SCHEMATIC DESIGN ASSESSMENT

5-7 Church Street
Nelson Bay NSW 2315
20 January 2025

Construction of a new 10 storey apartment building incorporating a pool, communal areas, and carparking levels

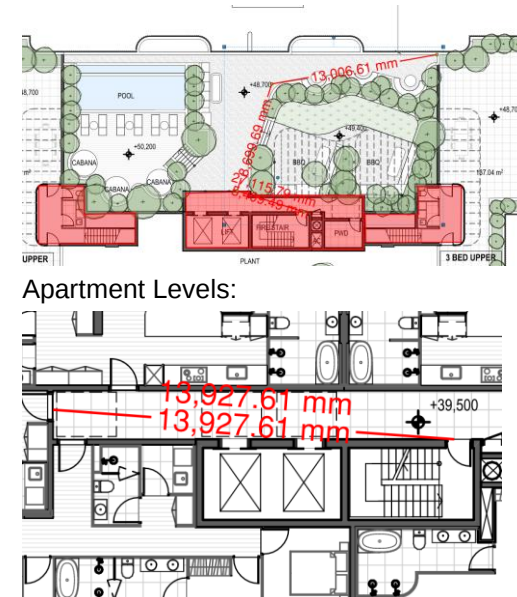
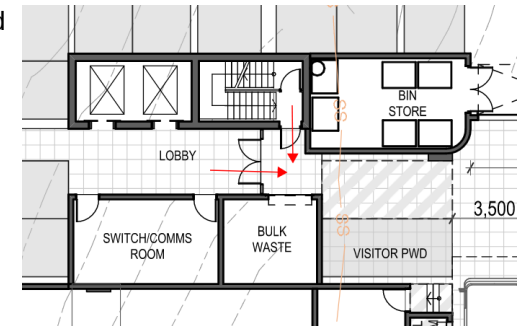
Currently the basement has 2 exits provided to both the apartment levels and basements, which is a DTS outcome.

Each apartment level is served via 1 exit from the fire isolated core, which is a DTS outcome.

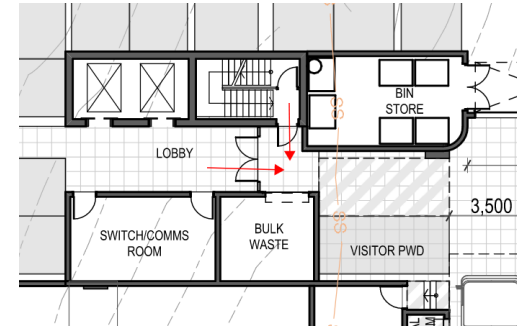
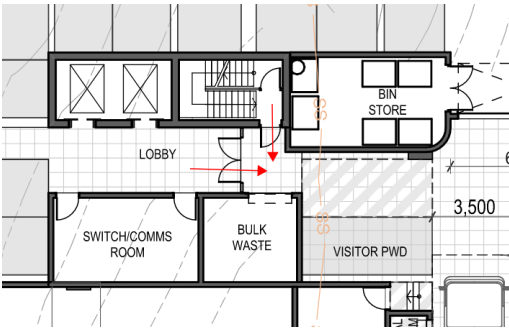
Item	Further Comment	Additional Info
Part D2D5 & D2D6– The following DTS exit distances apply under this part: 6m from a SOU front entry door to a point of choice on that floor where two exits are available and 20 m from a single exit serving the storey at the level of egress to a road or open space; and - no point on the floor of a room which is not in a sole-occupancy unit must be more than 20 m from an exit or from a point at which travel in different directions to 2 exits is available. 20m from an exit to any point on a floor of a class 5, 6 and 7a building or 20m to a point of choice where two exits are available in which case the maximum distance may not exceed 40m to one of those exits.	The following areas have extended travel distances: - Basement level 02 – more than 20m to a point of choice from the western portion of the basement (39m) - Basement 01 – more than 20m to the road/open space from the western portion of the basement (60m) - Roof Terrace - 27m from the most remote point in the BBQ areas to the core in lieu of 20m 14m in lieu of 6m for all apartment levels from the most remote SOU front door to the stair core ★ Fire engineer to assess all the above travel distances via FEA	 Basement 02:  Basement 01:  Roof terrace:

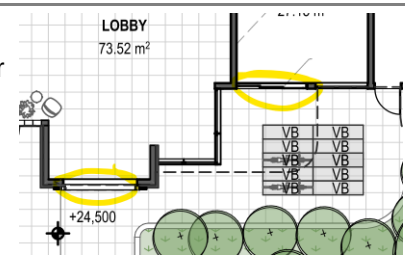
D2D6 - Access to alternative exits on every story must be distributed as uniformly as practicable within or around the storey served and in positions where unobstructed access to at least 2 exits is readily available from all points on the floor including lift lobby areas. Distance between alternative exits must not be less than 9m apart and not more than 45m apart

- ★ Part D2D6 (b) – Basement level fire isolated egress staircase discharge converges into basement level 01 egress pathway to be justified via FER

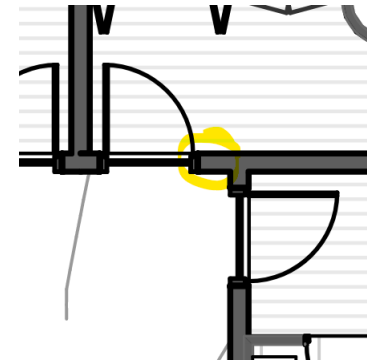
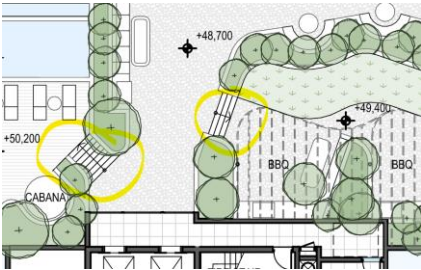
D4 - In regard to access for a person with a disability, all areas to the and within the building are considered as affected parts.	The following areas are required to be fully accessible in accordance with AS1428.1: • Approach access from street to the pedestrian entries to the main lobby. • All common areas to and within the building at ground level lobby, pool area and all common corridors. • Confirm level thresholds serving the office portions.	Typical details to be provided as part of Design Documentation. Architectural details to confirm the following: • Access from street to the pedestrian entries to the lobby and common areas including handrails, tactile ground indicators etc. • Enlarged details including full dimensions of accessible sanitary compartments, ambulant compartments, access ways etc.
---	---	---
